ADDENDUM NO. 3

DECEMBER 22, 2023

PREPARED BY SCHMIDT ASSOCIATES FOR:
FRYEBURG SHOOTING RANGE
MAINE DEPARTMENT OF INLAND FISHERIES & WILDLIFE

BGS PROJECT #2742

1C Sound Wall Door Elevation
Scale: 1" = 1'-0"

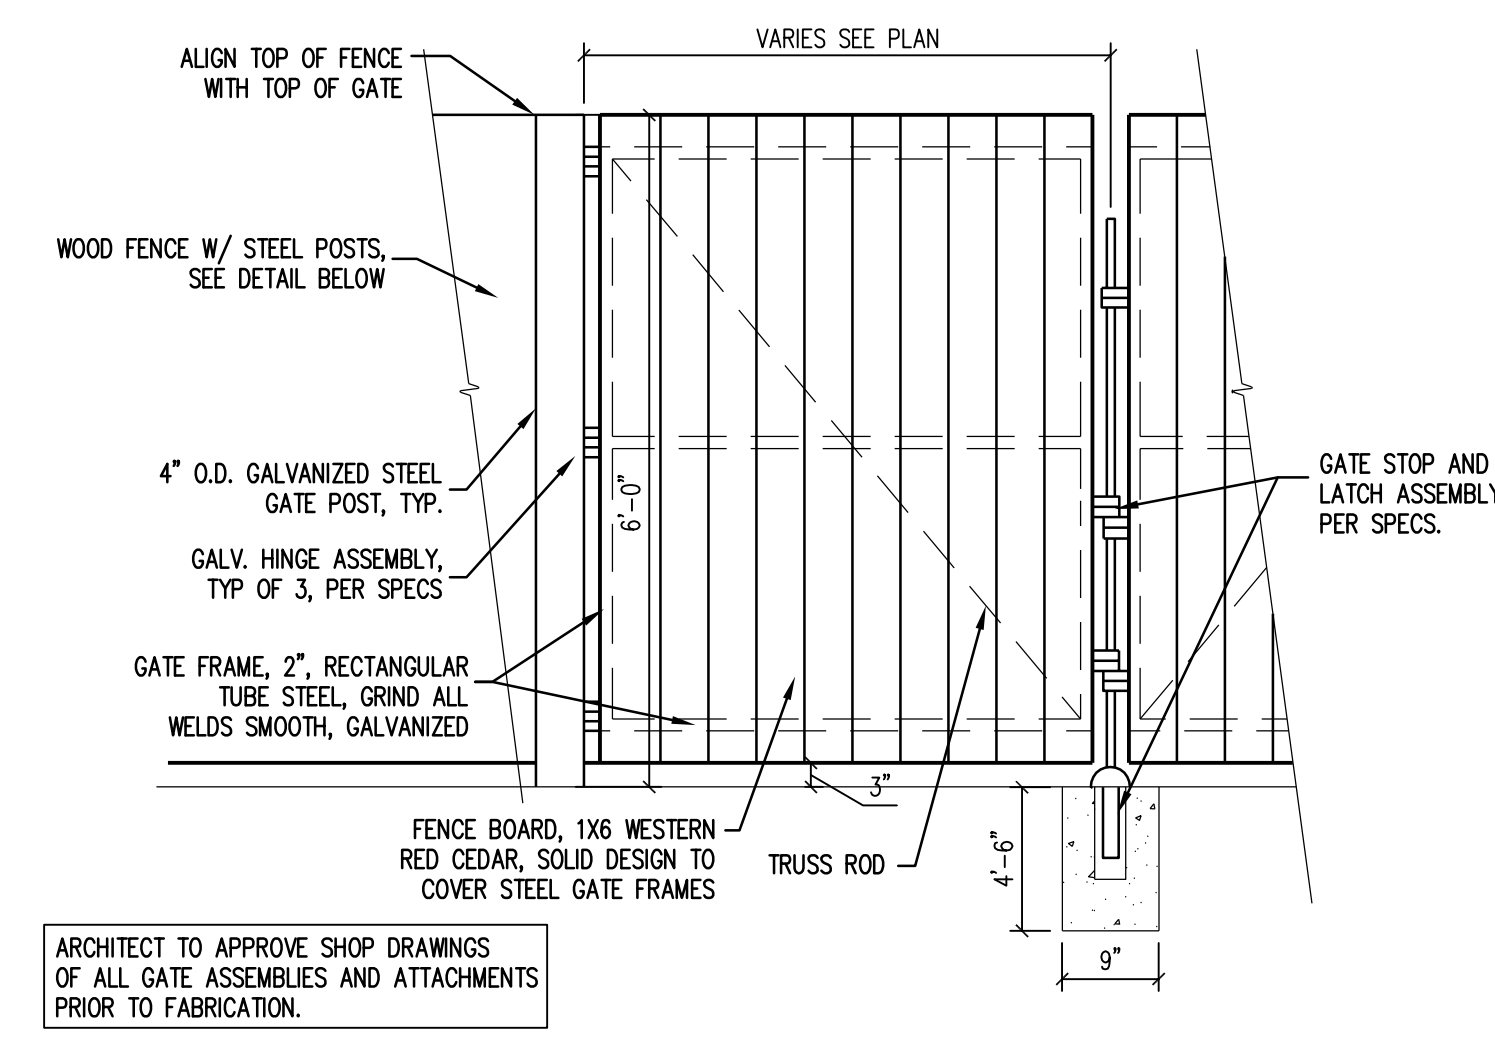
- a. *The 20' wall height may be considered the true wall height from bottom of bottom panel to top of top panel.*
3. Regarding the sound absorptive barrier: The specifications call for the door to be made of the same sound absorptive precast material as the panels. Windows cannot be added into this style of door. Can the doors be an 'off the shelf' double-wide steel door? See photo from similar project:

- a. *The door may be an 'off the shelf' double-wide steel door per the specifications.*
4. Regarding the sound absorptive barrier: Please confirm whether hot dip galvanized is allowed for the steel posts with no painting.
